SERVICE BULLETIN No. 088

Turbocharger Center Housing Inspection

Figure-1 - Center Housing Identification

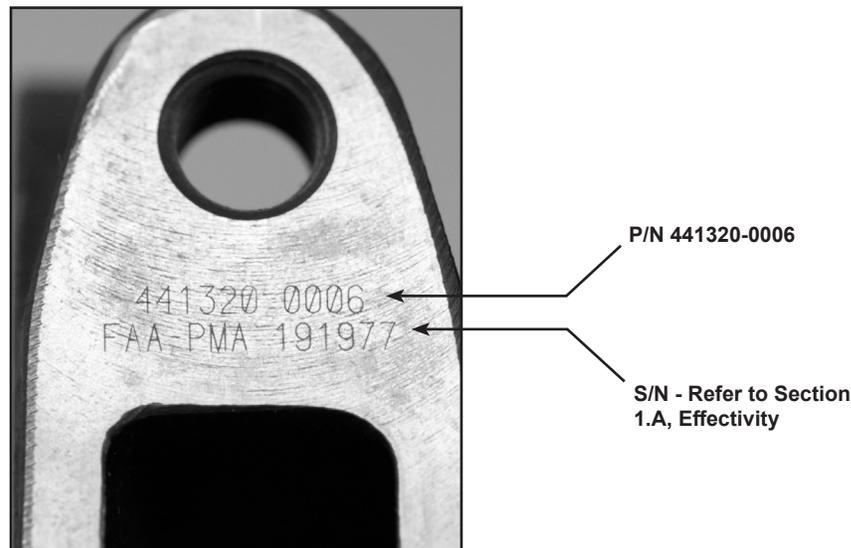
- (a) If the turbocharger **is** affected, utilize the applicable aircraft maintenance manual to gain access to and remove the turbocharger center housing oil drain line from (lower) flange. Inspect the turbocharger center housing P/N and S/N against criteria found in section 1.A of this SB. (See Figure-1 for serial number illustration)

- 1) If the turbocharger center housing **is** affected per section 1.A, continue to 3.B., Corrective Action.
 - 2) If the turbocharger center housing is **not** affected per 1.A, reinstall oil drain reservoir onto the turbocharger center housing lower port per applicable aircraft/engine maintenance manual and continue to 3.C. - Return to Service.
